Amendment #A00003 - PreBid RFIs

PROJECT: UPGRADE UNDERGROUND UTILITIES – TEMPLE VAMC
VA PROJECT NUMBER: 674-10-101
BID DATE: 06-05-14

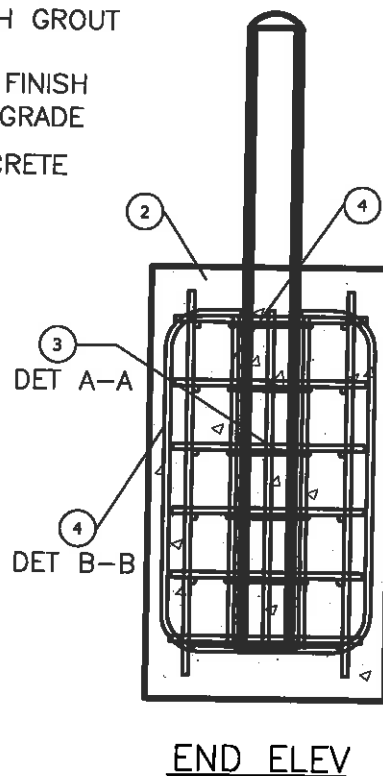
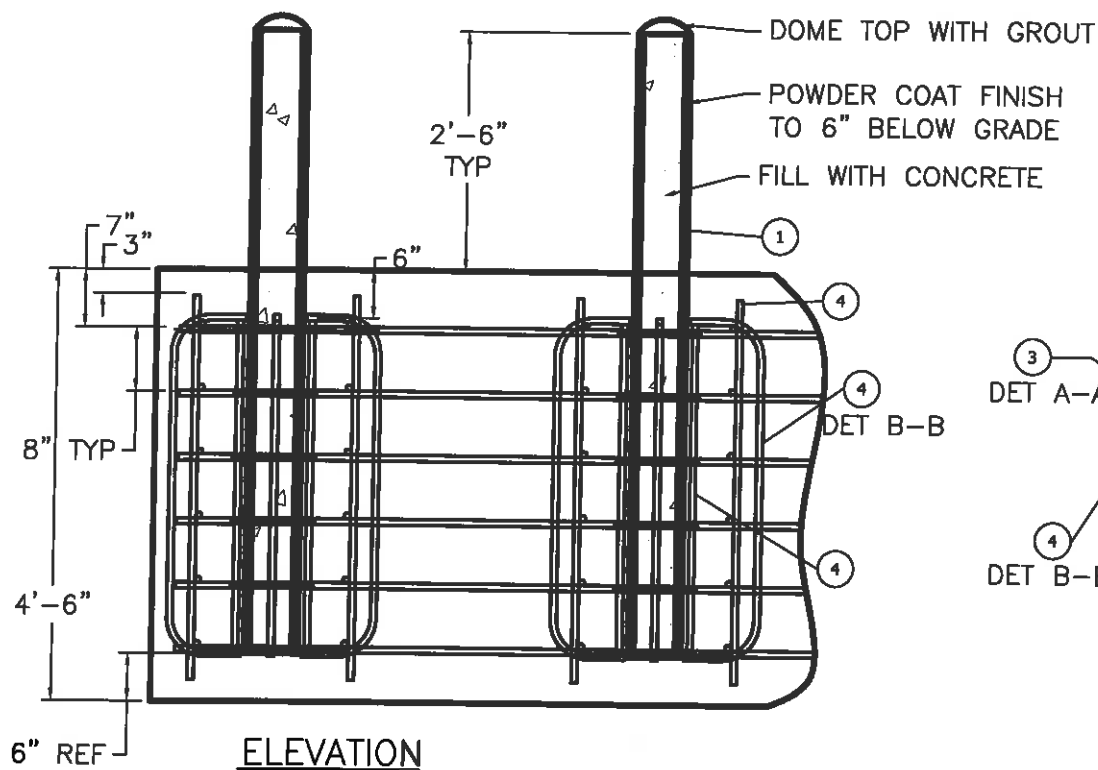
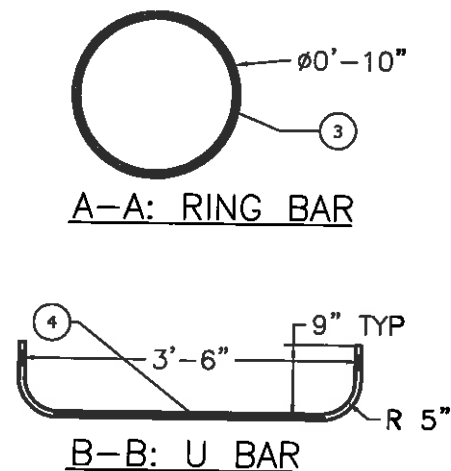
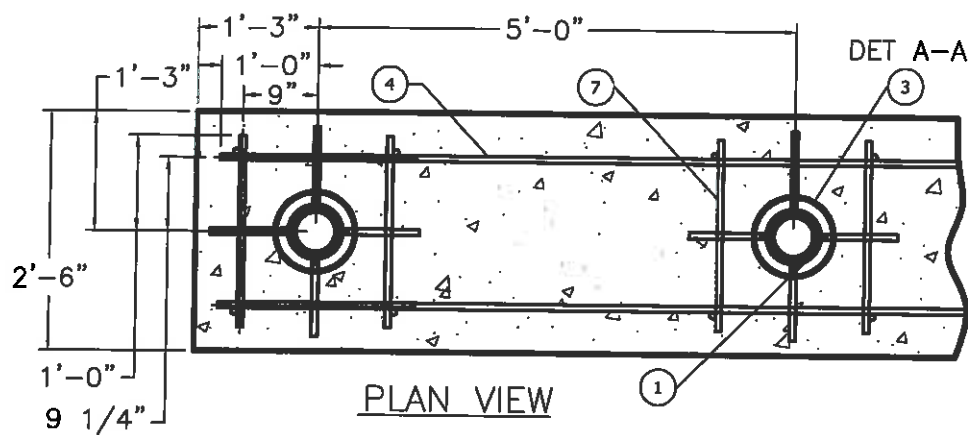
7. The flexible pavement detail on sheet C7.4 detail @ shows the flexible pavement detail to consist of 2" of Type D hot mix, 12" of limestone base & compacted subgrade. The Geotech Report does not have this section on sheet 6 of the report. Please confirm that we are to bid the flexible pavement per detail 2 on sheet C7.4 and per the paving detail on sheet C7.6.

The flexible pavement section to be used should be DI-2 Option 2B. This pavement section, as provided by the geotechnical engineer, will be used in lieu of the pavement section shown on the Civil Engineers Details.

Existing IT Building Bollard

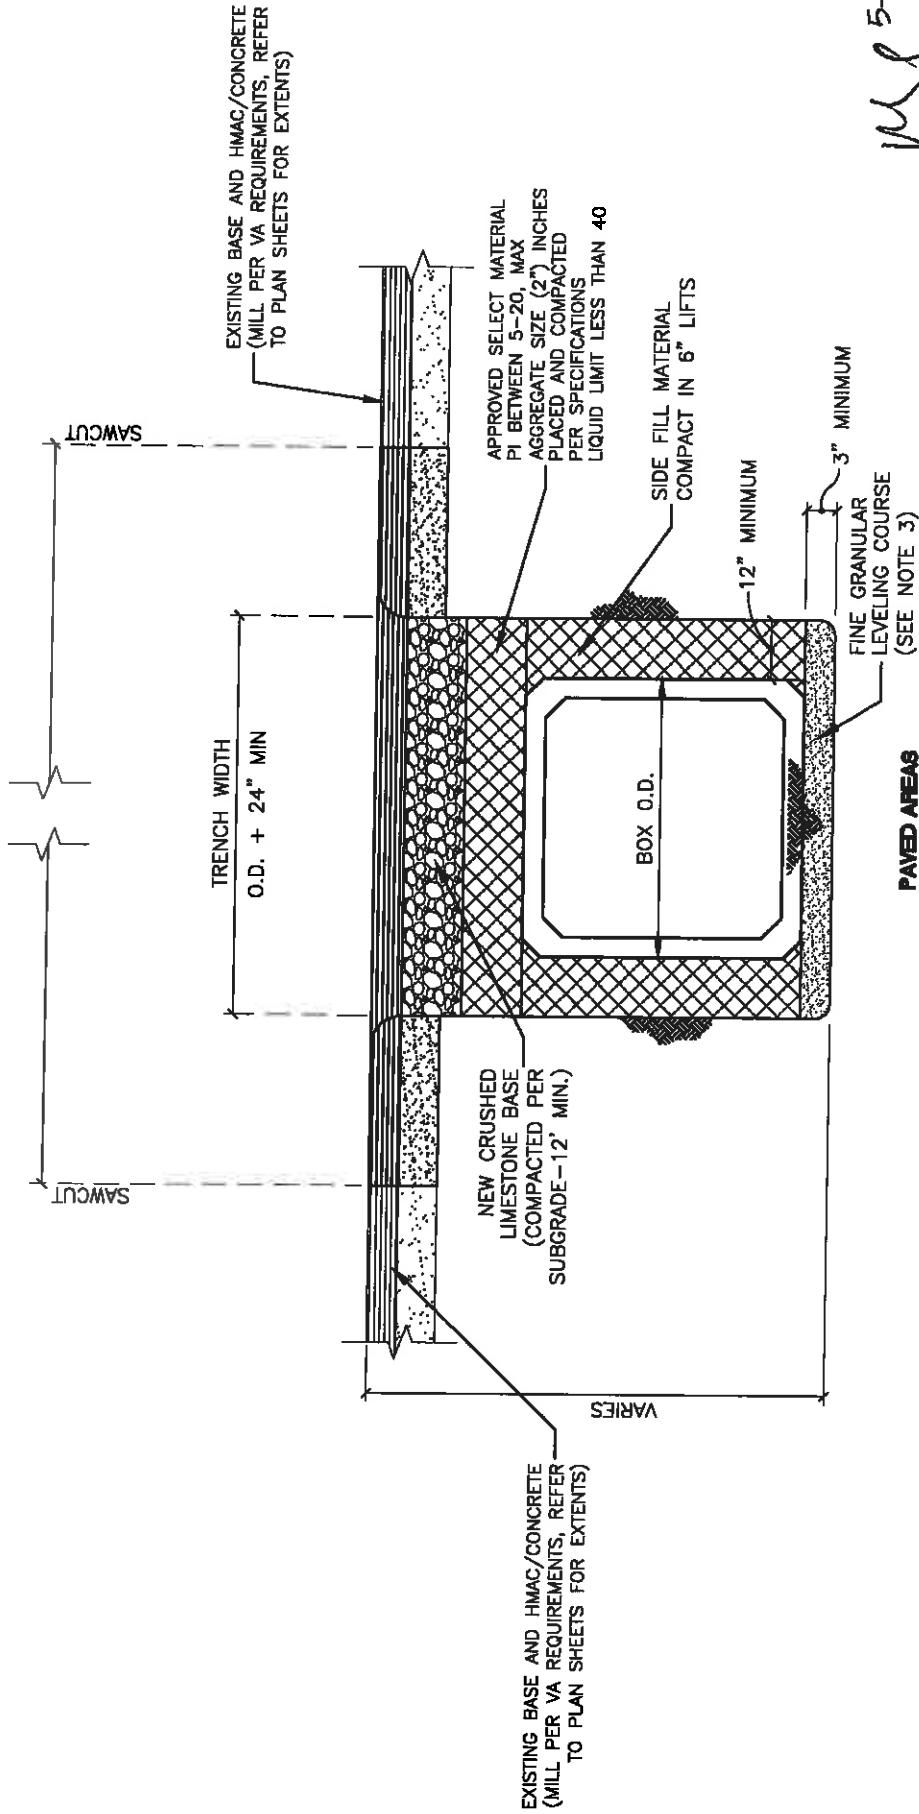
1. Sheet AM3-1 – Detail showing existing security bollards at the IT building to be removed and replaced as required for installation of tunnel. Number and linear footage of bollards determined by width of excavation.
2. Sheet AM3-C1 – Detail showing the pavement replacement detail for the project.
